May 10, 2019

**Re: Contextual Site Plan Amendment – Waterstone Filing 3 CSP  
Aurora, CO  
Application Number: DA-1758-09  
Case Number: 2019-4006-00  
Response to Referral Comments**

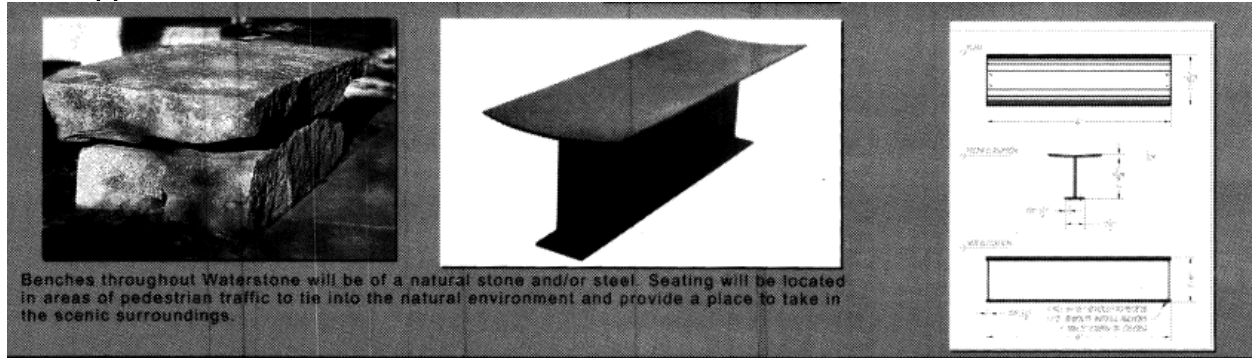
- B. Will there be any entry monumentation on E Ohio Avenue or E Ford Drive? The FDP shows a design theme for monuments, including a median. The illustration below is from the FDP. While there is not enough width on the street to do a median, are there any other treatments that can be done to conform with the design vision?

**Response: Monument sign has been added to E Ford Drive, it has been located within a planted landscape area adjacent to road since the road isn't wide enough for a median.**
